UNITED STATES PATENT AND TRADEMARK OFFICE

APPLICATION NO.	FILING DATE	FIRST NAMED INVENTOR	ATTORNEY DOCKET NO.	CONFIRMATION NO.
09/804,105	03/12/2001	Norbert A. Feliss	SJ0920000138US1	8988

Office Action Summary

FIG. 5

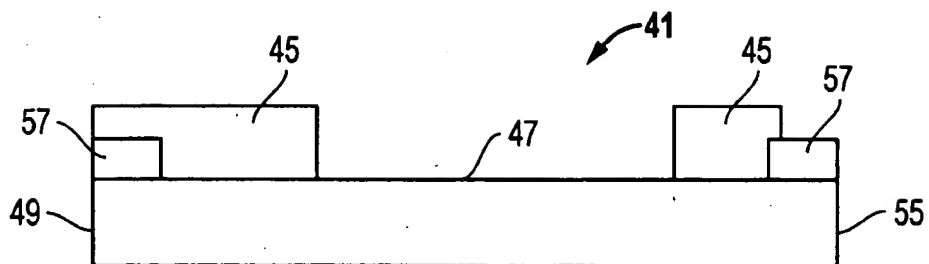
1. The new drawing sheet was received on 1/18/05. This drawing is acceptable.
